MEMORANDUM

TO: Planning Commission Members
FROM: Michael A. Lumbis, Planning and Community Development Director
PRIMARY REVIEWER: Geoffrey T. Urda
SUBJECT: Sketch Plan Approval – 1248 Washington Street
DATE: March 28, 2024
Request: Sketch Plan Approval to reconstruct and reconfigure the interior parking lot circulation at **1248 Washington Street**, Parcel Number 14-13-101.001
Applicant: Michael B. Lasell, P.E., of MBL Engineering
Proposed Use: Restaurant
Property Owners: DRZ, Inc.

JRECK SUBS
1248 WASHINGTON STREET
CITY OF WATERTOWN
JEFFERSON COUNTY

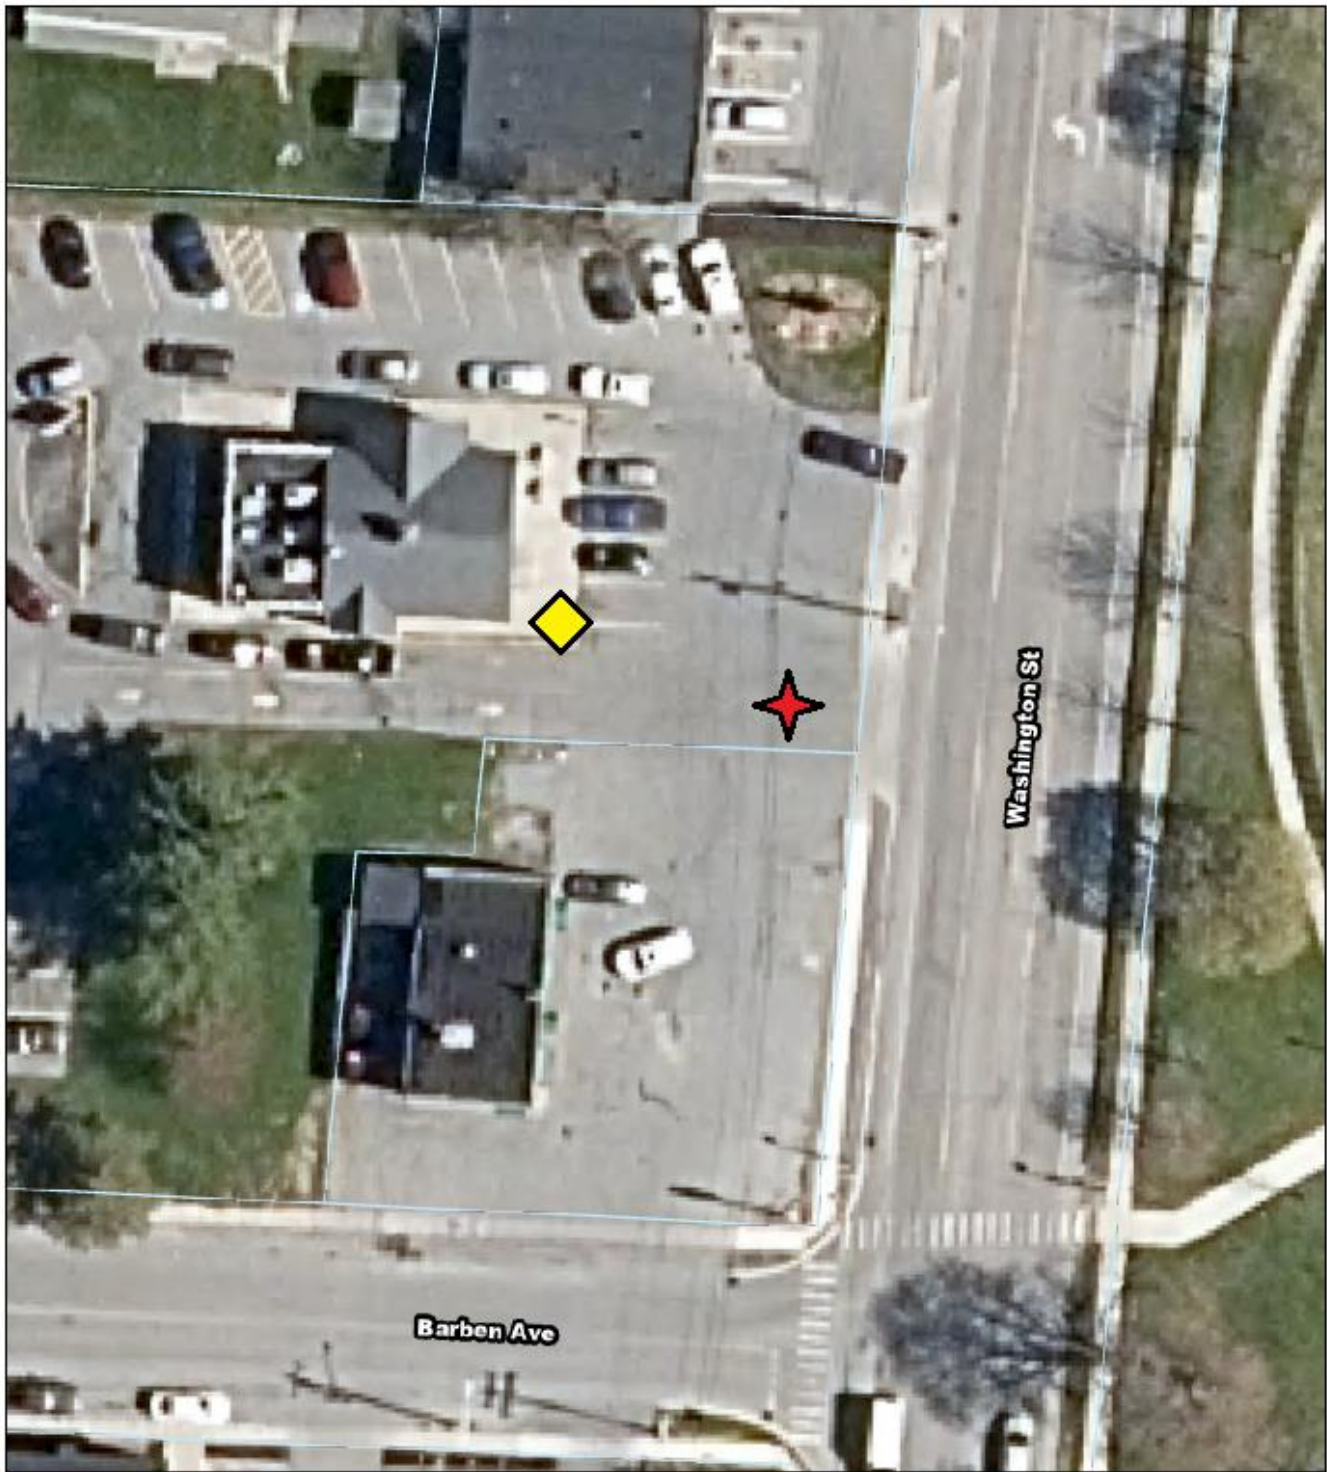
Above: A view of the existing entrance from Barben Avenue, including the area where Staff recommends installing new curb to better delineate the separate entrances in lieu of the proposed hatching.
Below: A view of the south (Barben Avenue) frontage, looking due west with the paved margin continuing into the distance.

1. The applicant shall install a new curbed island in the area that separates the southern drive aisle entrance from the four parking spaces directly accessed from Barben Avenue, in lieu of the hatching depicted on the C-102 drawing, to better delineate the access points from one another.

SHEET #
C-102

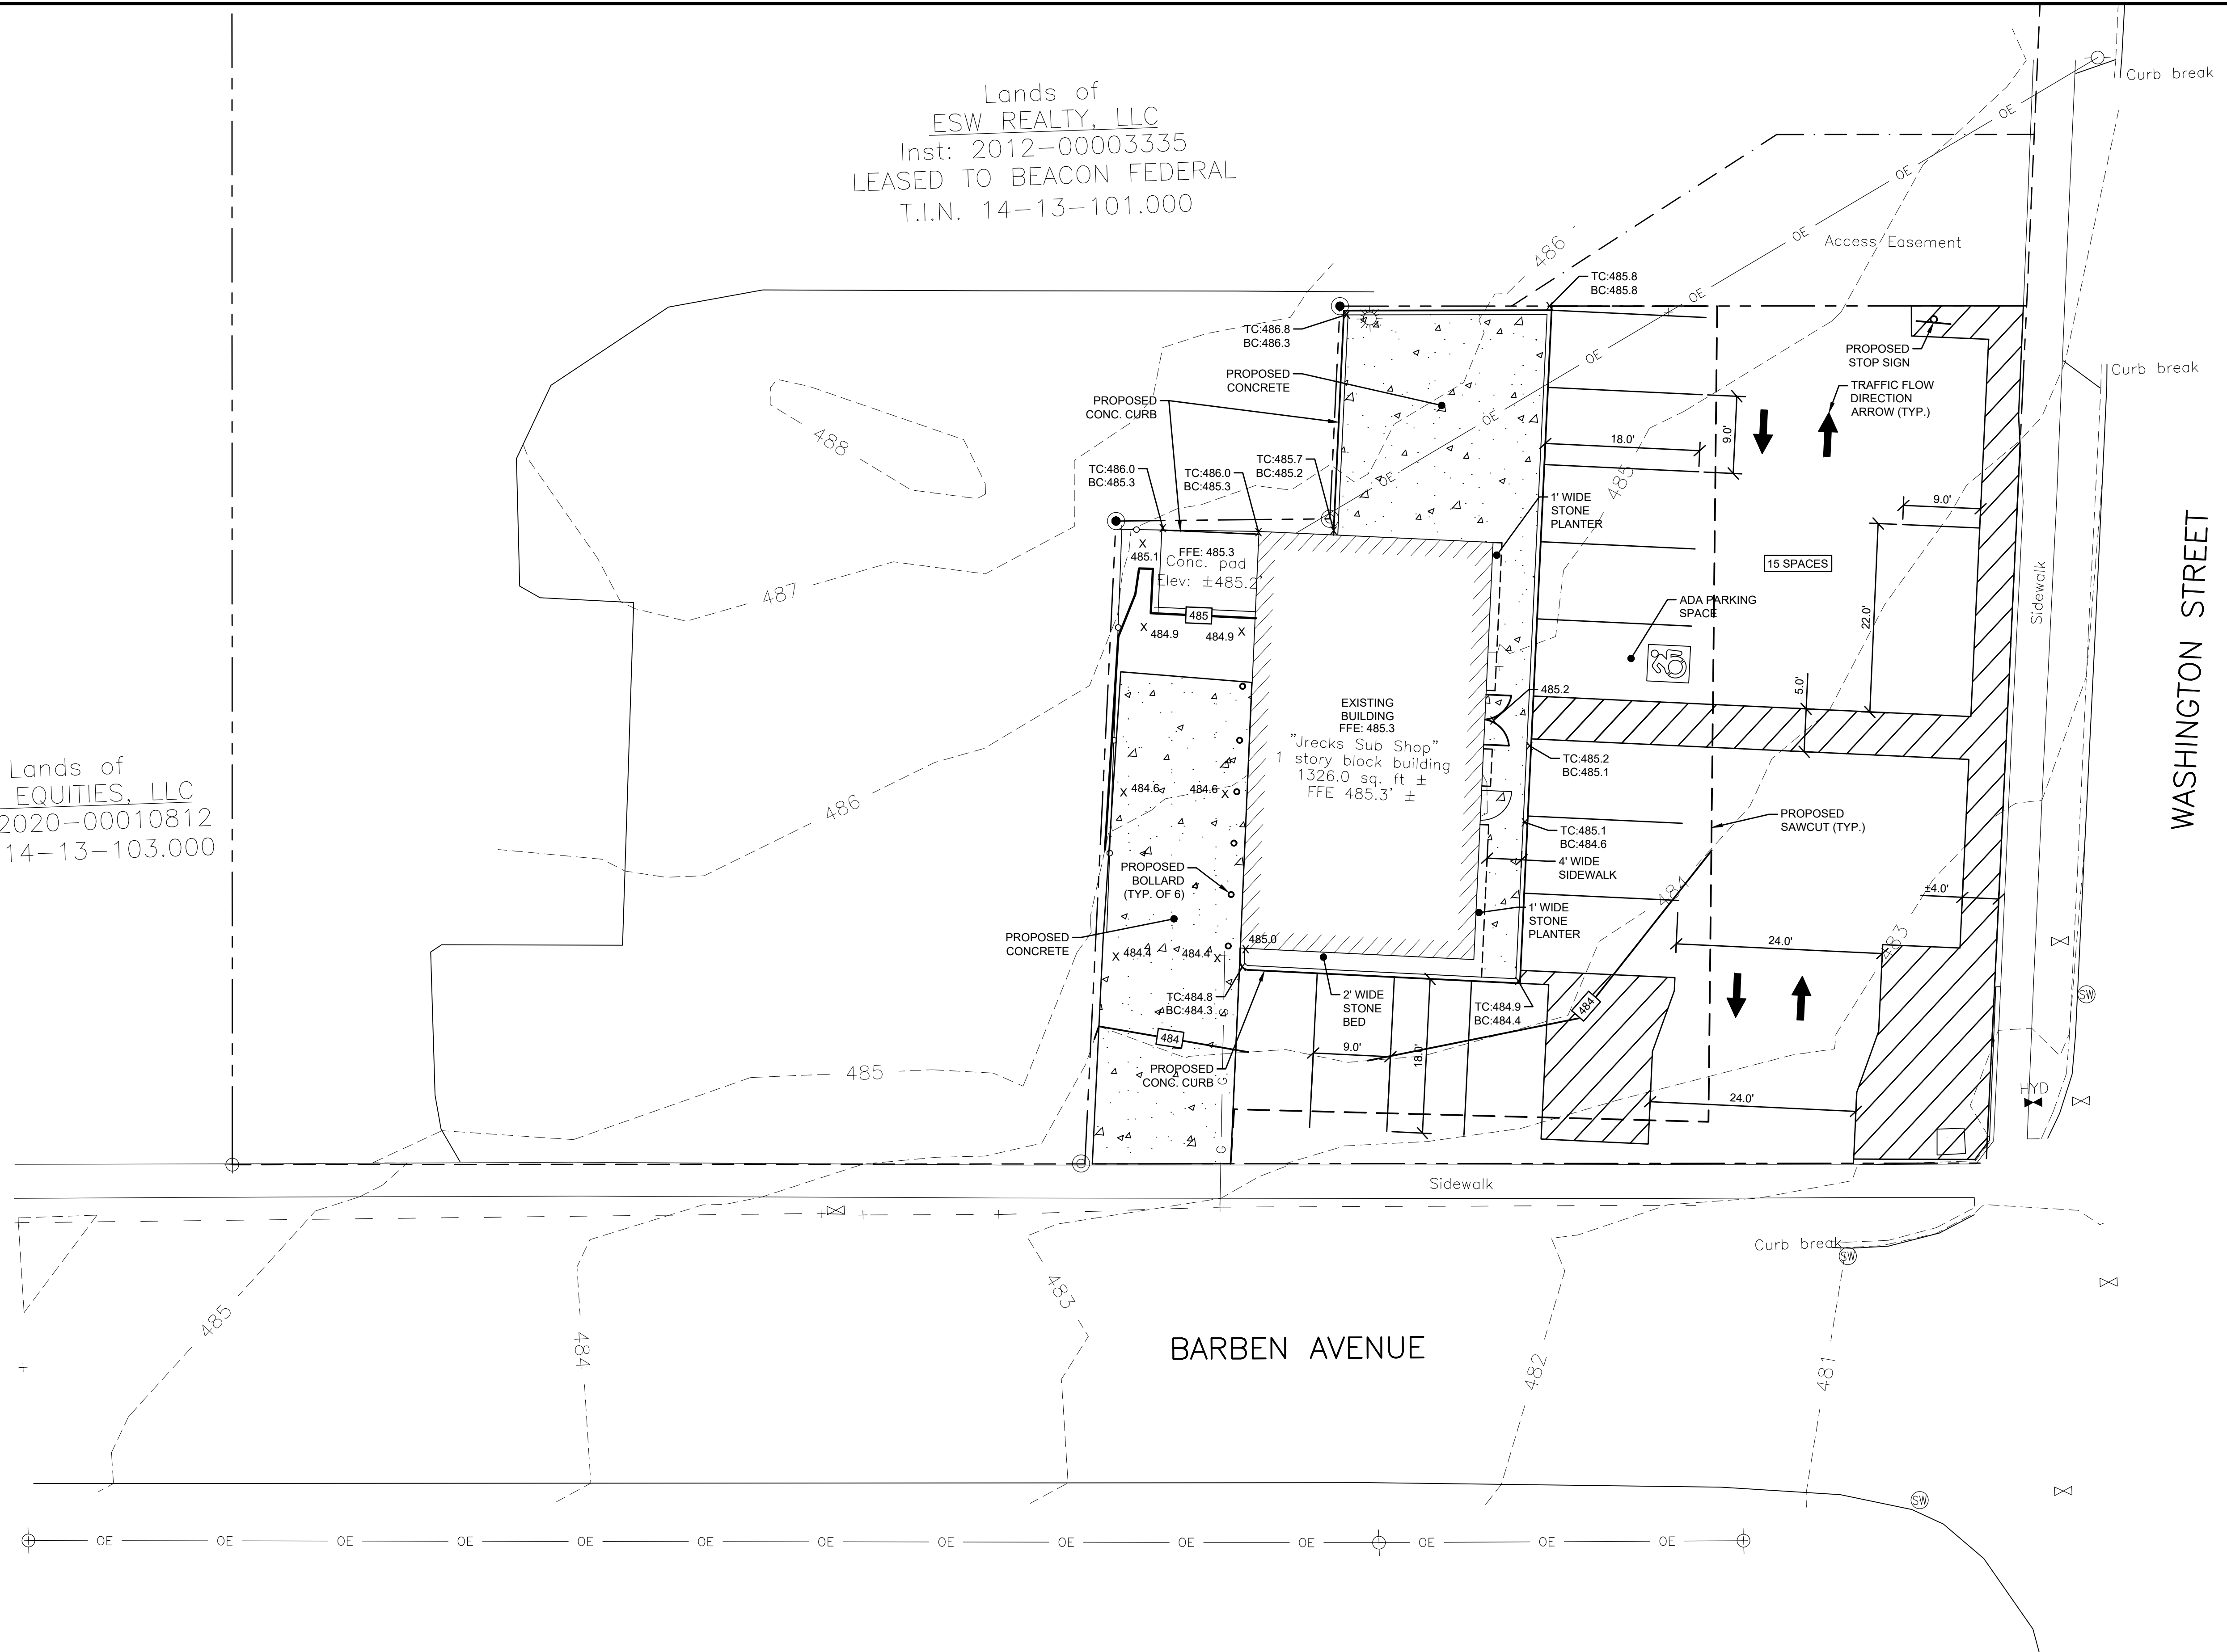
Presently, there is no existing curb on the south edge of the parcel. Instead, there is a continuous paved margin that runs for several hundred feet along the north side of Barben Avenue. The applicant proposes an approximately 14' x 19' hatched area that would separate the southern drive aisle entrance from the four spaces directly accessed from Barben Avenue. Staff recommends that the Planning Commission require the applicant to install a new curbed island in lieu of the proposed hatching, which would better delineate the proposed access points from one another.

Engineering: In addition, the applicant proposes one nine-foot-wide ADA accessible parking space adjacent to a five-foot-wide access aisle. While Federal ADA standards only require a site to provide one ADA space if there are 25 or fewer total spaces in the lot, this space must be van accessible. Published Department of Justice (DOJ) guidance offers two methods for making an ADA space van accessible.

Option #1 is to provide a 132-inch (11-foot) wide parking space adjacent to a 60-inch (five-foot) access aisle. Option #2 is to provide a 96-inch (eight-foot) wide parking space adjacent to a 96-inch (eight-foot) wide access aisle. The applicant must reconfigure the single-proposed ADA space to be van accessible by implementing one of the DOJ's two options for creating a van accessible space. The applicant may choose their preferred option.

In addition, the access aisle must lead to ADA accessible curb ramp that provides access to the store entrance. The C-102 drawing appears to depict a continuous curb along the entire front of the building.

Finally, the City Engineering Department will require using a multidirectional breakaway post for the proposed Stop sign at the northern end of the interior drive aisle.

3. The applicant should strongly consider planting grass in the four-foot wide buffer between the Washington Street sidewalk and three proposed interior parallel parking spaces, instead of the proposed hatched paint.

4. The applicant must reconfigure the single ADA accessible parking space on the site to meet the United States Department of Justice’s standards for a van accessible space.

5. The applicant must provide an ADA accessible curb ramp providing access from the hatched ADA access aisle to the front entrance to the building.
6. The applicant shall install a multidirectional breakaway post for the proposed Stop sign at the northern end of the interior drive aisle.
